OCD-SW-08-0616

Osceola County – SW
J.E.D. Solid Waste Management Facility – Class I
Partial Closure of Side Slopes of Phase I – Intermediate Modification
First Request for Additional Information
Modification of Permit No.SO49-0199726-010
Permit Application No.SO49-0199726-011

Figure 2 - Site Plan
City of St. Cloud Transfer Station
Osceola County, Florida

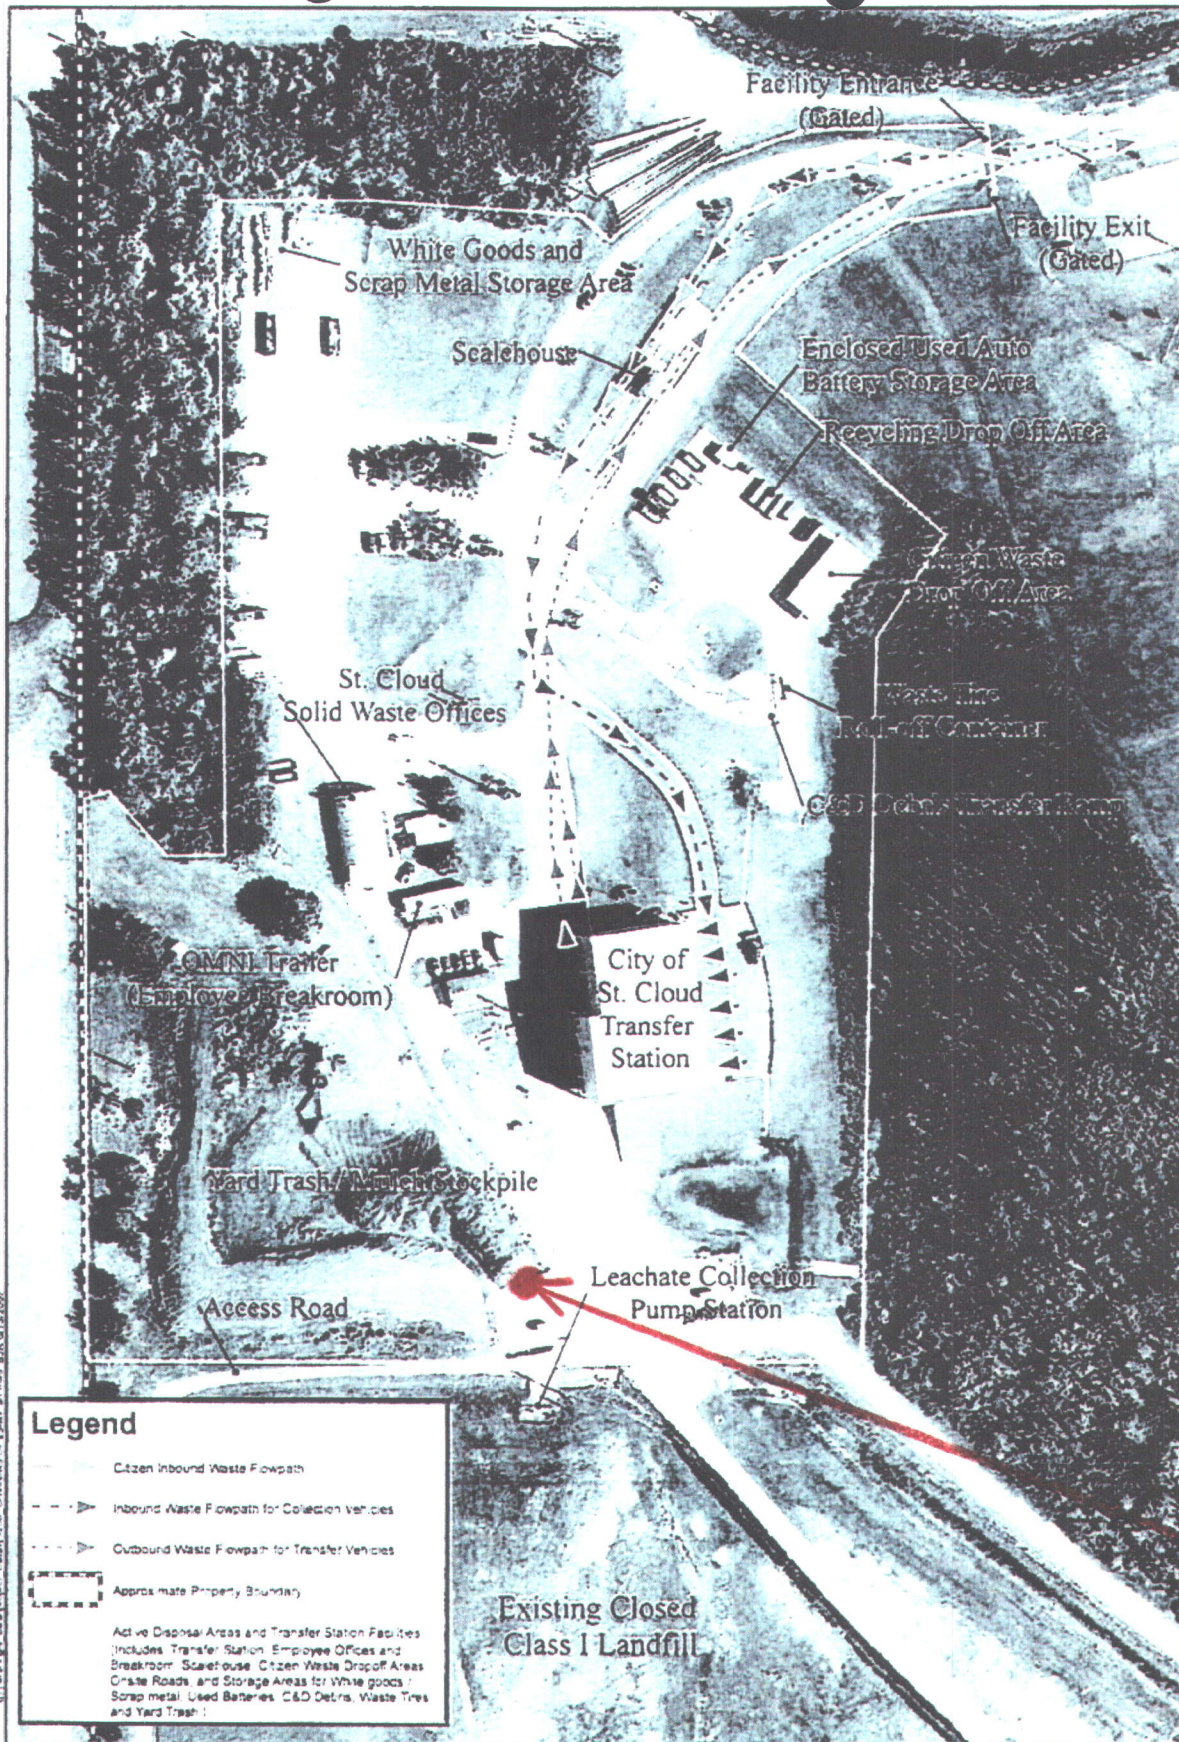
You mention the leachate storage facility will be constructed on property where the closed St Cloud landfill and active Omni Waste transfer station exists. From the drawing it appears the storage facility will not be built on the closed landfill and it will be a separate operation from the waste transfer station. If I am correct, then a

permit modification is not necessary. We do ask that you send us a formal letter with that information, including a site plan. If the storage facility becomes part of the transfer station operations or if it is built over the closed disposal area, a permit modification must be submitted.

Yes you are correct - please see the attached figure as confirmation. The facility will be built on the transfer station permitted property and will be independent of the operation of the transfer station. I will forward a formal letter as you requested once we clear all permitting hurdles with the City of St. Cloud.
